HISTORIC AND DESIGN REVIEW COMMISSION

February 05, 2020

HDRC CASE NO: 2020-033
ADDRESS: 418 MISSION ST
LEGAL DESCRIPTION: NCB 945 BLK 2 LOT 32
ZONING: RM-4 CD, H
CITY COUNCIL DIST.: 1
DISTRICT: King William Historic District
APPLICANT: SCHEFF DENIESE M & CRITTENDEN ROBERT JR
OWNER: SCHEFF DENIESE M & CRITTENDEN ROBERT JR
TYPE OF WORK: Amendment to rear addition windows
APPLICATION RECEIVED: January 17, 2020
60-DAY REVIEW: March 16, 2020
CASE MANAGER: Huy Pham

1. Amend the previously approved fenestration pattern and window specifications for the rear addition.
2. Restore the front porch deck and balcony slope.

Historic and Design Review Commission
Design Review Committee
Report & Recommendation

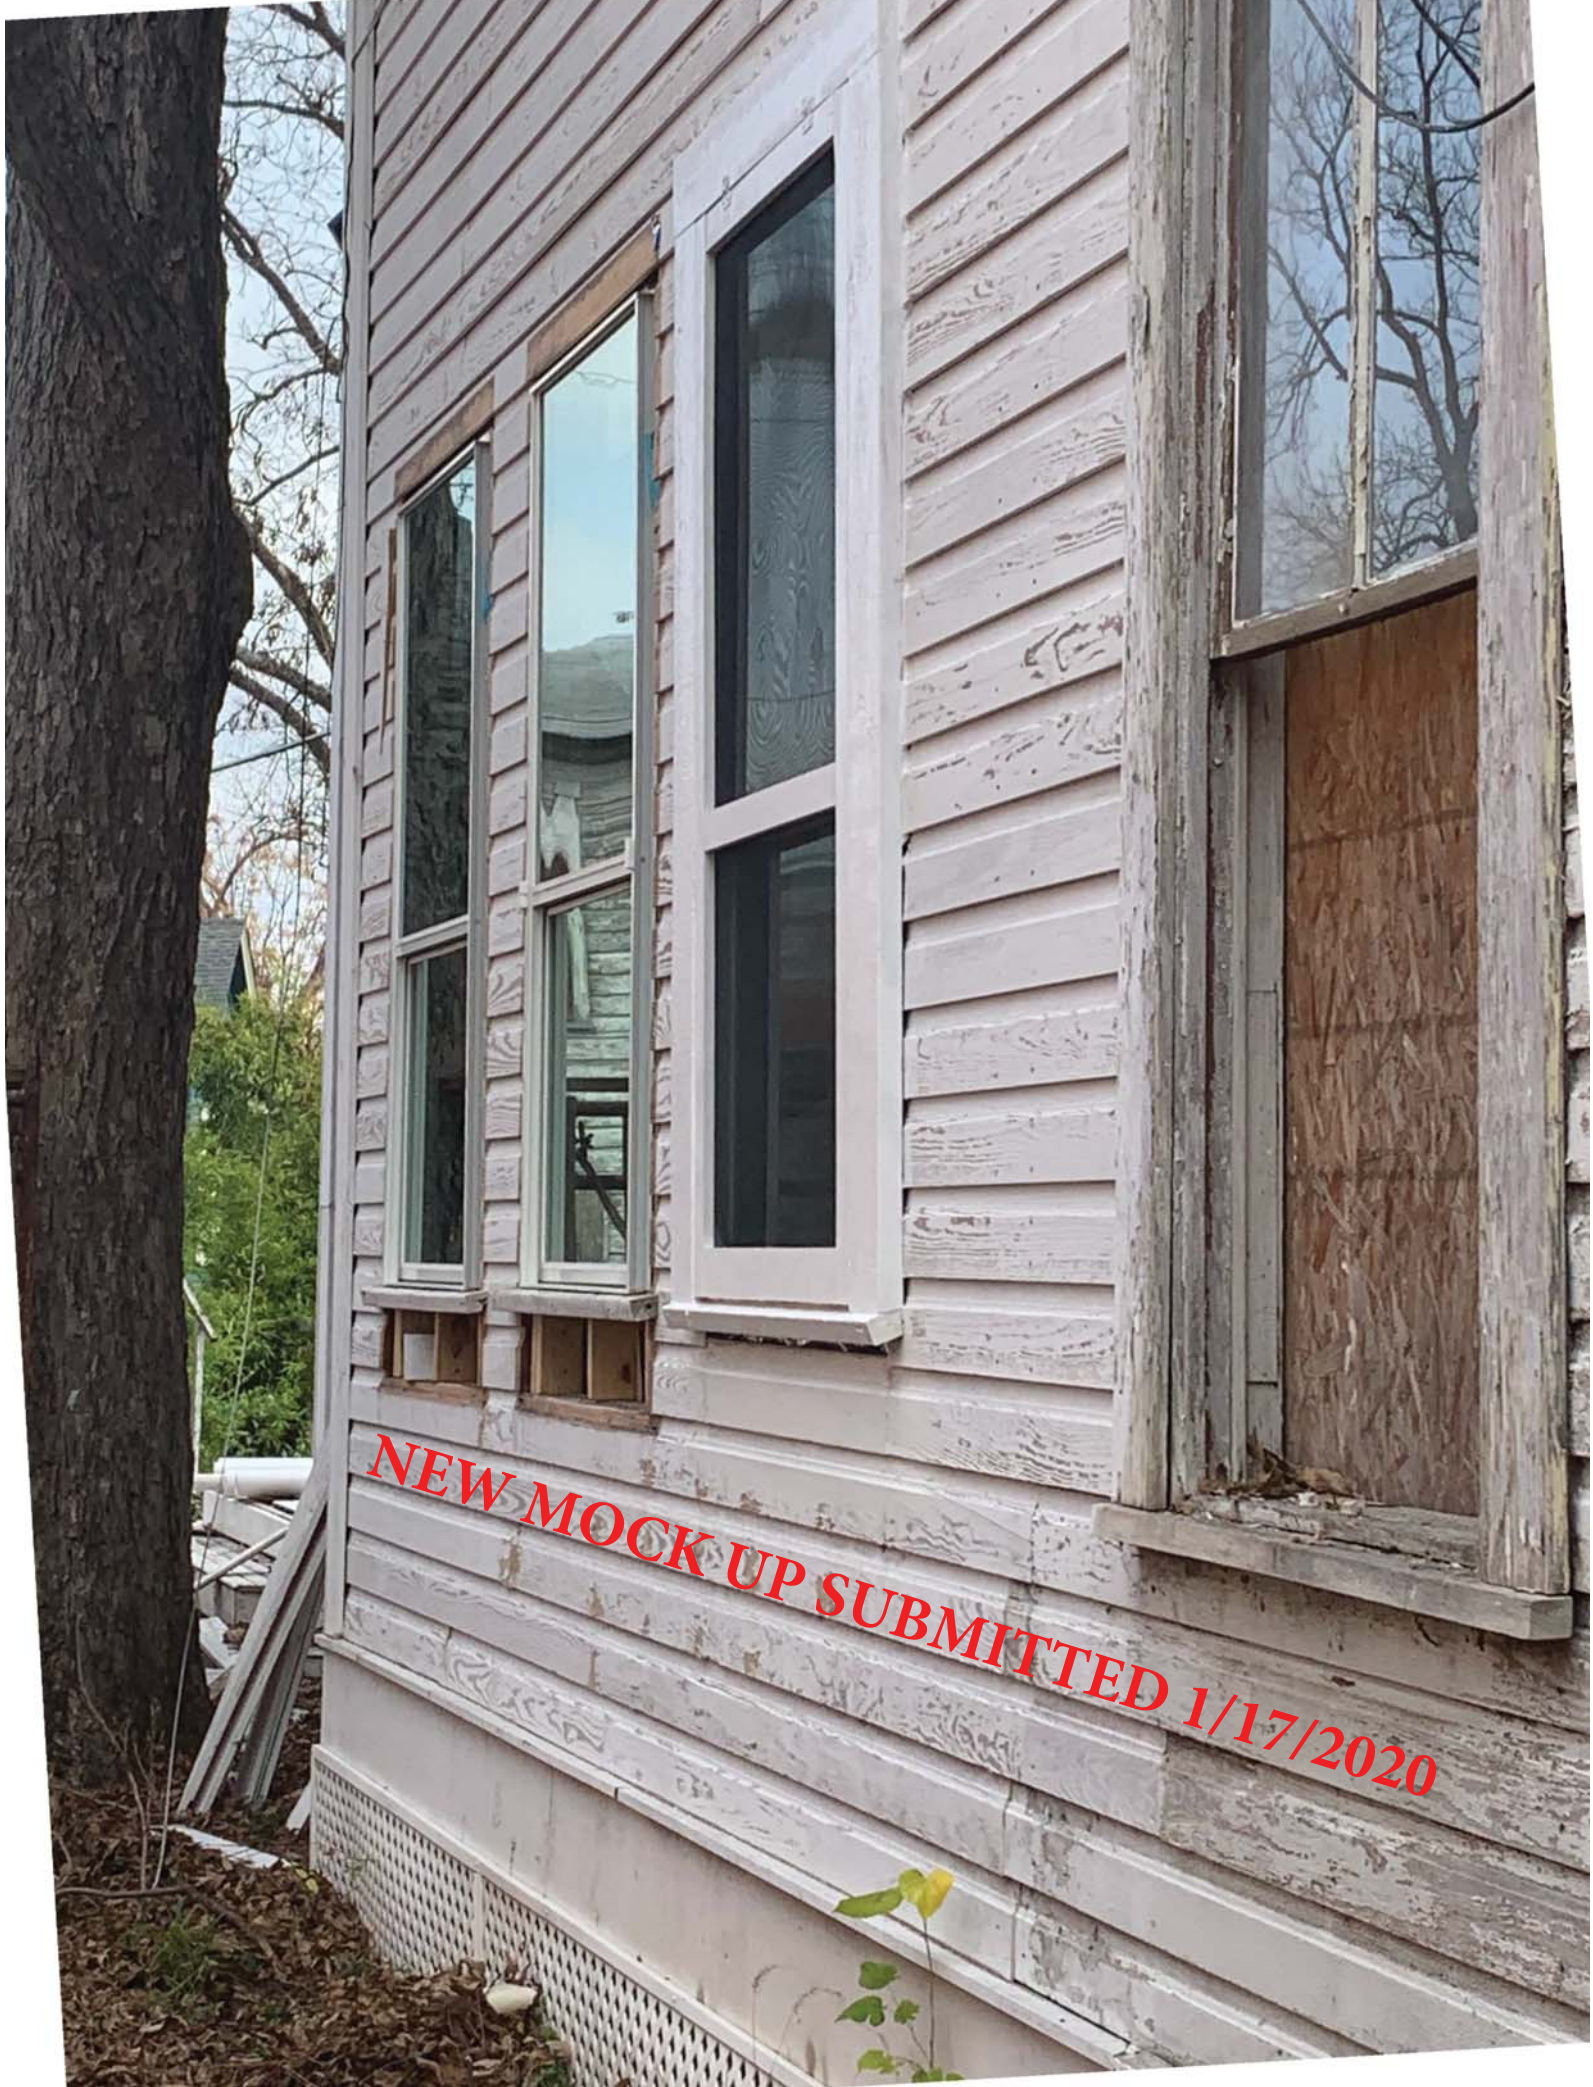
- original sill heights may be allowed with safety glass.
- ~~various~~ permitting issue considered as exception
- window trim should use 2x6 instead
- window screen should be 2 (1x6) match exactly (taller bottom rail)
- center meeting rails should match historic windows.
- REAR BAY WINDOW: SPLIT WITH SCREEN

COMMITTEE RECOMMENDATION: APPROVE [] DISAPPROVE []
APPROVE WITH COMMENTS/STIPULATIONS:

1st Floor

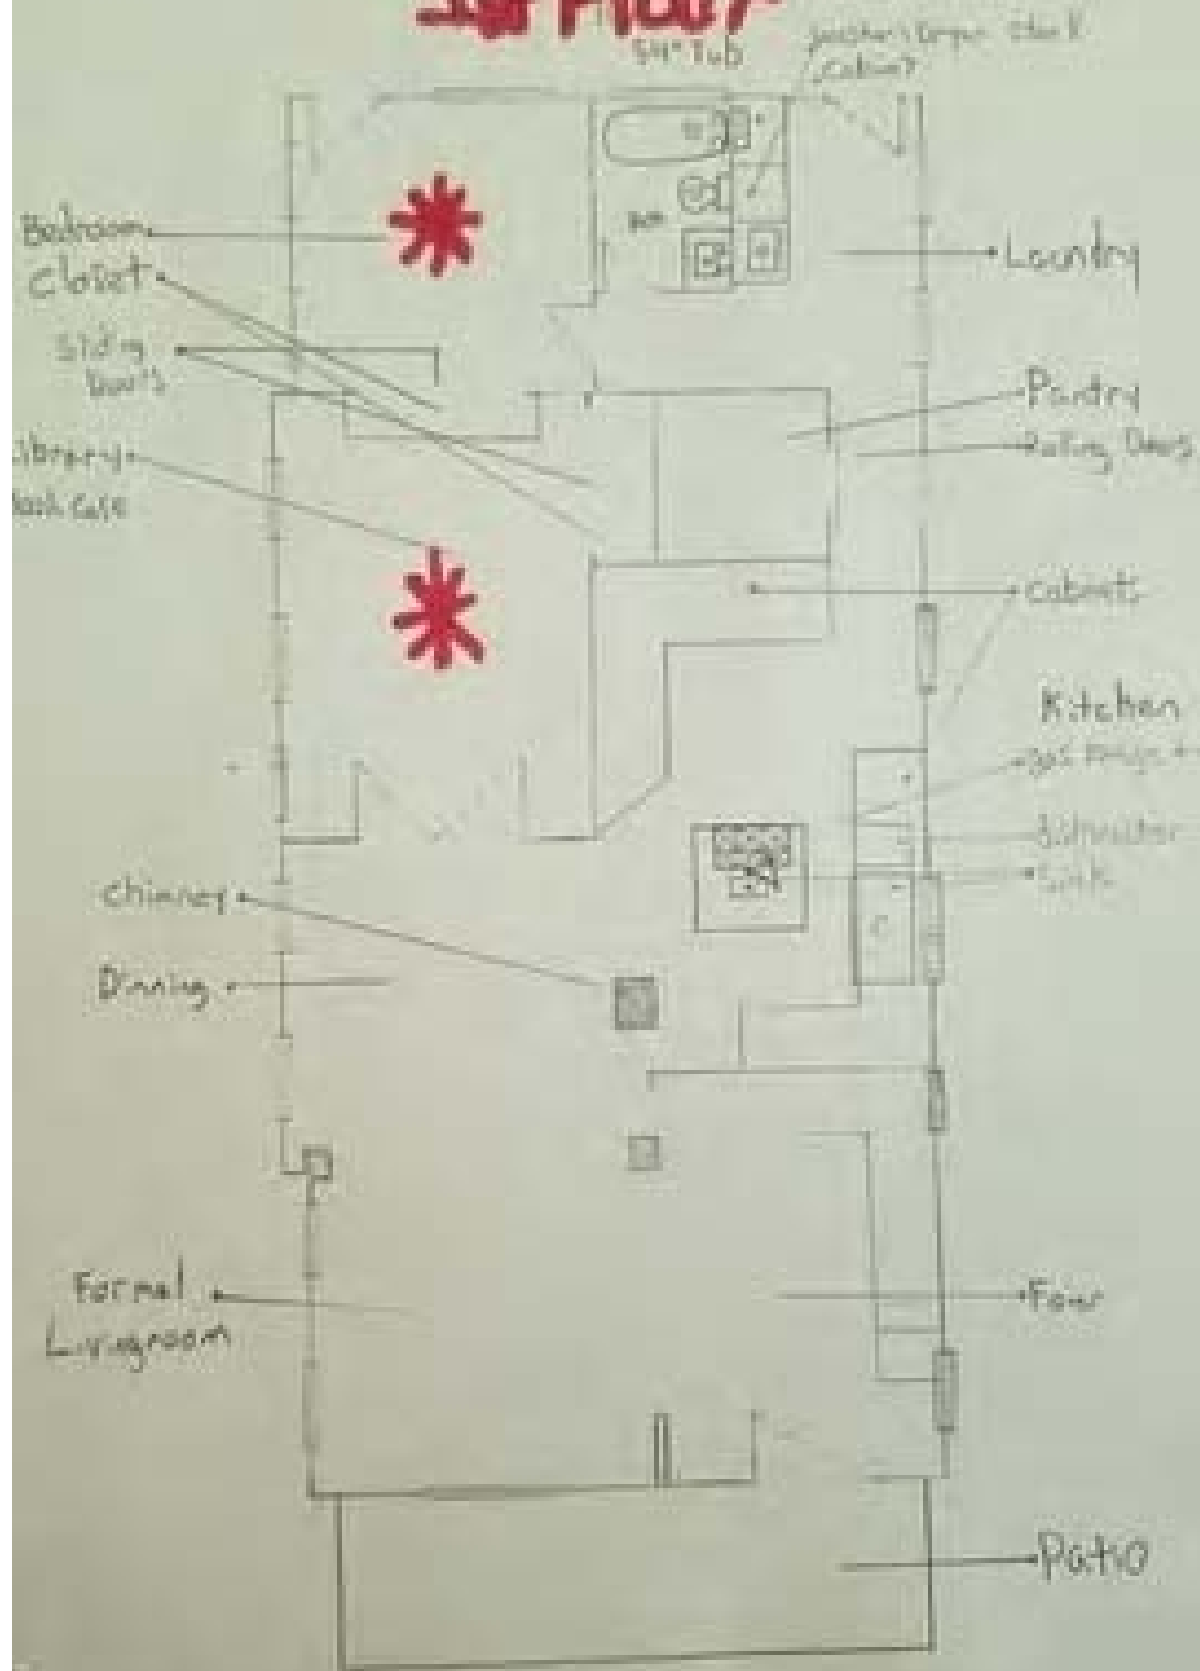
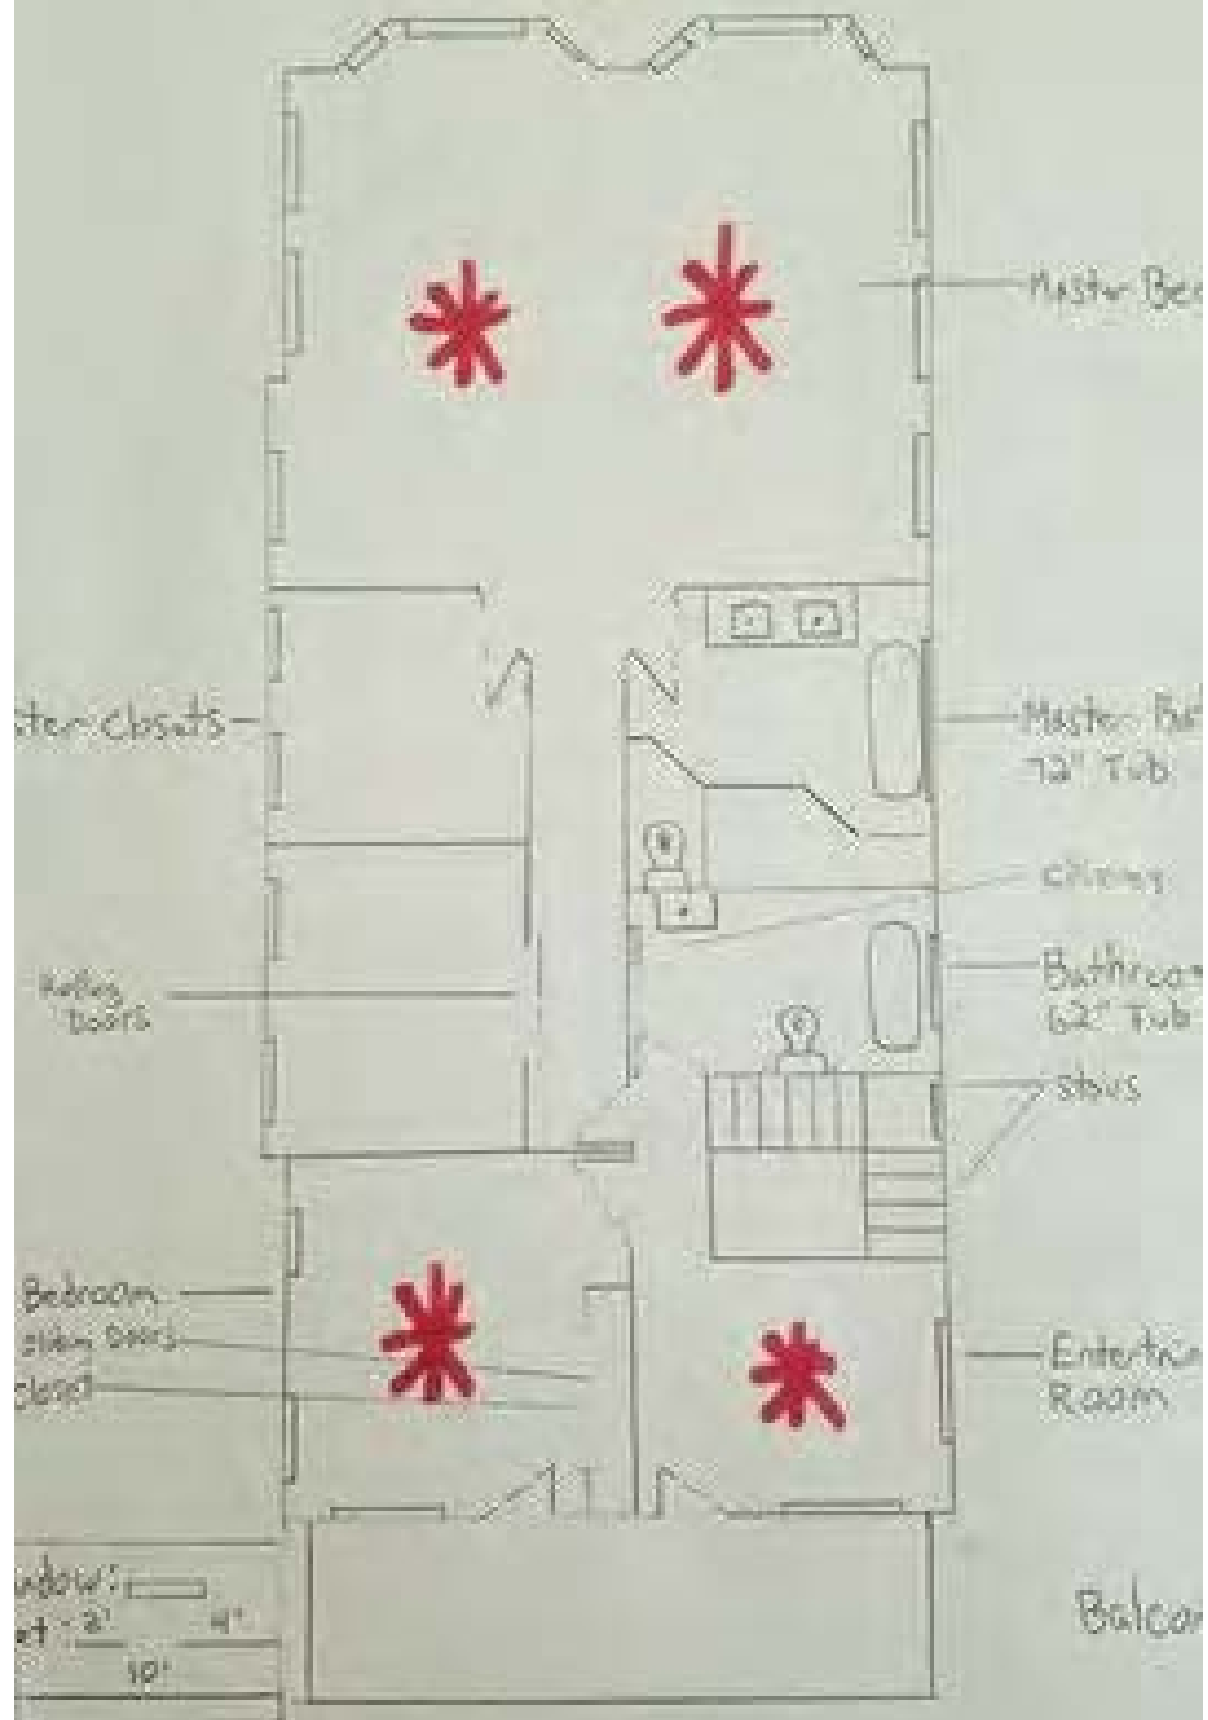
Build New Window = [REDACTED]
